UNITED STATES PATENT AND TRADEMARK OFFICE

APPLICATION NO.	FILING DATE	FIRST NAMED INVENTOR	ATTORNEY DOCKET NO.	CONFIRMATION NO.
10/650,350	08/28/2003	Jeffrey J. Norris	2316.1486USC1	6705

Office Action Summary

DETAILED ACTION

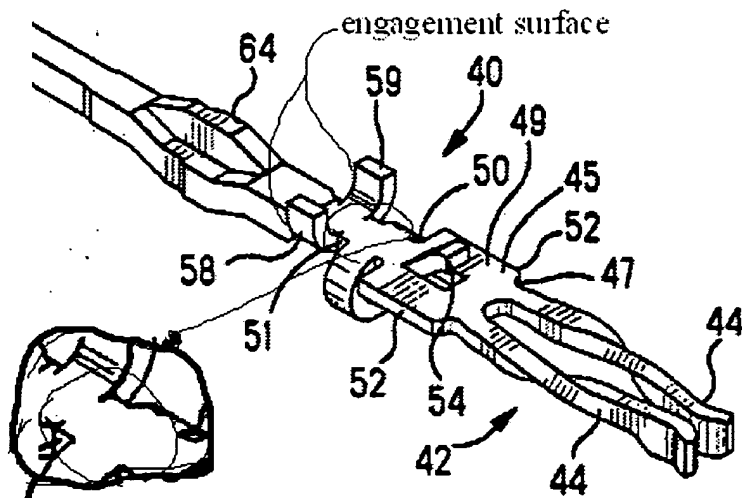
** Claim(s) 8, 11, and 12 is/are rejected under 35 U.S.C. 102(b) as being anticipated by Ruehlemann (3231848).

-- In reference to Claim(s) 8, Ruehlemann shows (figure 7)

- a) a first section (see examiner's figure) that receives an electrical contact;
- b) a second section (see examiner's figure) that can be configured for insertion into a through hole of a circuit board, and with 1st and 2nd pin members (see examiner's figure),
- c) a third section integral with the first and second section (see examiner's figure), the third section including:
 - i) a contact surface oriented generally perpendicular to the

longitudinal axis, the contact surface can be configured to receive a force applied to position the electrical contact within the through hole of the circuit board (see examiner's figure);

- ii) at least three integral engagement surfaces opposite the contact surface (see examiner's figure),

the engagement surfaces can be configured to contact the circuit board to limit the depth of insertion of the electrical terminal within the through hole of the circuit board.

-- In reference to Claim(s) 11, Ruehleemann shows (see examiner's figure) a plurality of projections 224 extending from, and spaced apart from the third section of the electrical terminal (see examiner's figure).

-- In reference to Claim(s) 12, Ruehleemann shows (figure 7) at least one of the plurality of projections 224 is located on a side of the electrical terminal opposite the other projections.

shoulder construction further defining the push surface of each of the arms

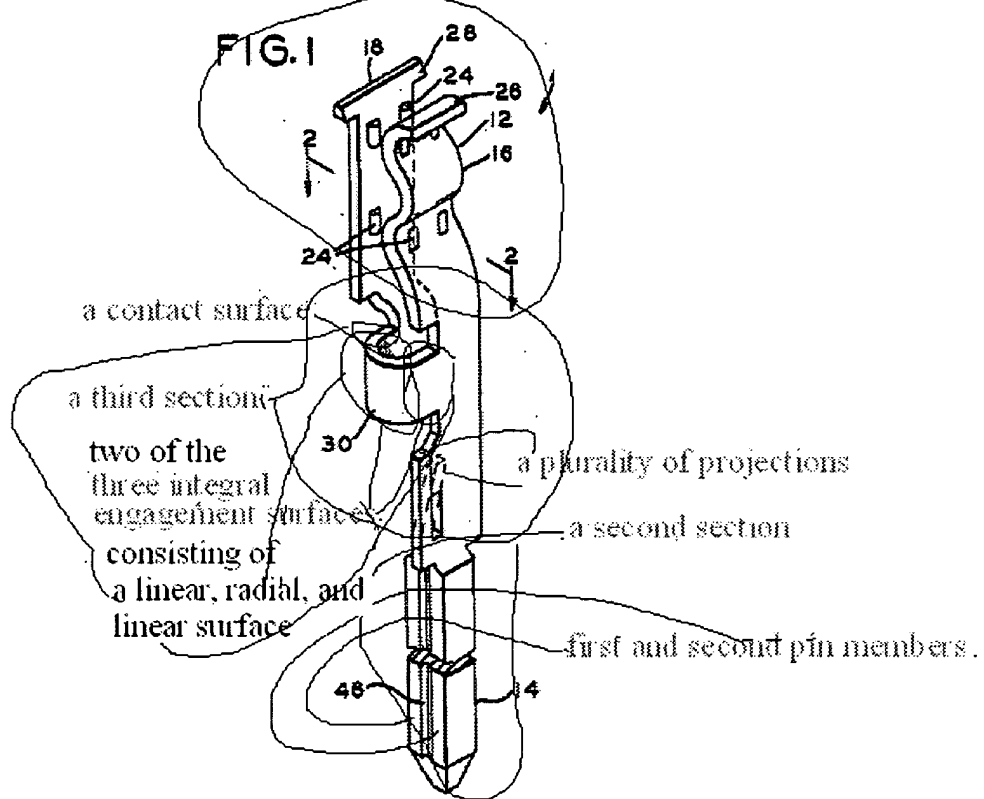
** Claim(s) 1-7 is/are rejected under 35 U.S.C. 102(b) as being anticipated by Costello et al. (5139446).

-- In reference to Claim(s) 1, Costello shows (cover sheet)

a) a terminal body having a first end 42, a second end 62, and a longitudinal axis extending between the first and second ends,

b) an insertion structure 40 positioned between the first and second ends of the terminal body, the insertion structure including arms (50, 52, 58, and 59) extending from the terminal body and extending in a direction generally parallel to the longitudinal axis of the terminal body, each of the arms including:

i) a push surface (near the lead line of numeral 51);

ii) an engagement surface oriented opposite the push surface (see examiner's figure).

-- In reference to Claim(s) 2, the insertion structure has three arms, at least one engagement surface is on at least one of the three arms and is located on a single plane generally perpendicular to the longitudinal axis of the terminal body (see examiner's figure).

-- In reference to Claim(s) 3, Costello shows (cover sheet) the insertion structure 40 includes a shoulder (radius between arms and the longitudinal axis and element 47 on arms 52) construction interconnecting each of the arms, the shoulder construction further defining the push surface of each of the arms (see examiner's figure).

a first section that receives an electrical contact;

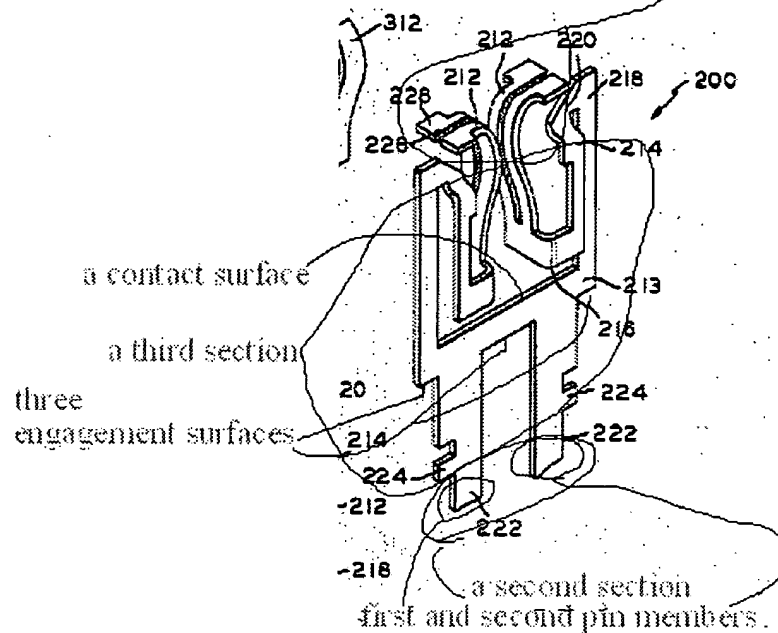
** Claim(s) 8-11, 13, and 14 is/are rejected under 35 U.S.C. 102(b) as being anticipated by Travis (3142891).

-- In reference to Claim(s) 8, Travis shows (figure 1)

- a) a first section (see examiner's figure) that receives an electrical contact;
- b) a second section (see examiner's figure) configured for insertion into a through hole of a circuit board, and 1st and 2nd pin members (see examiner's figure),
- c) a third section integral with the first and second section (see examiner's figure), the third section including:
 - i) a contact surface oriented generally perpendicular to the longitudinal axis, the contact surface can be configured to receive a force applied to position the electrical contact within the through hole of the circuit board;
 - ii) at least three integral engagement surfaces opposite the contact surface (see examiner's figure), the engagement surfaces can be configured to contact the circuit board to limit the depth of insertion of the electrical terminal within the through hole of the circuit board.
